HISTORIC PRESERVATION COMMISSION

STAFF REPORT Department of Growth Management

MEETING DATE:	October 5, 2016
PROJECT:	1321 May River Rd. (Lot 1, CSP) – New Construction
APPLICANT:	Kevin Grenier, KRA, Inc.
PROJECT MANAGER:	Erin Schumacher, AICP, Senior Planner

PLAN REVIEW COMMENTS FOR COFA-08-16-010035

A2.2

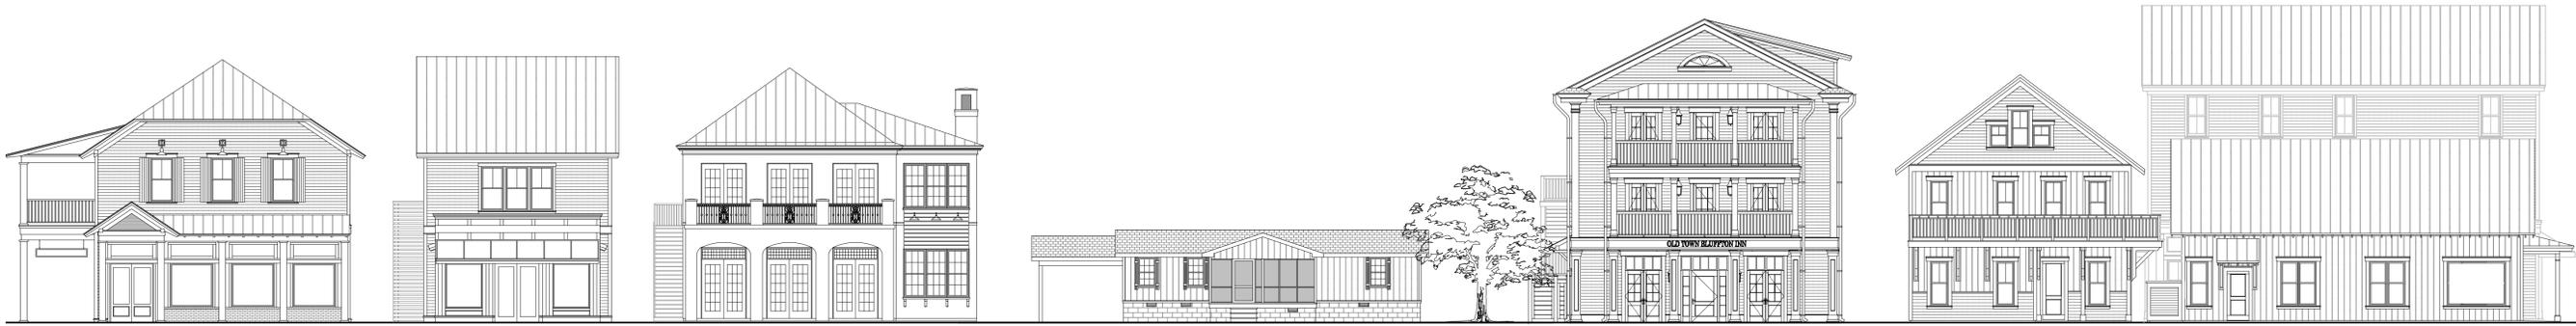
2. The column capitals on the first floor elevation are ill proportioned with the width of the column below and should be revised to have a better proportional relationship. As well, the corner board of the upper levels should be increased in width to have better proportion to the columns below. These corner boards should wrap the corner and be the correct size on the side elevation as well. (UDO Section 5.15.5.F.4.a. and Traditional Construction Patterns Section 6)

4. The window/door head casing of the third floor windows/doors should be equal to or wider than the jamb casing, and should not be less than one-sixth the opening width. The current configuration appears to have a head casing detail that is too narrow and different than the other windows/doors and should be revised for consistency. (UDO Section 5.15.6.A. and Traditional Construction Patterns Section 38)

5. Provide additional information and an architectural detail of the proposed louvered A/C vents under the windows. (Applications Manual)
- Recommendation: The right side elevation would benefit from a faux louver or additional architectural detailing on the panel between the two stacked windows.
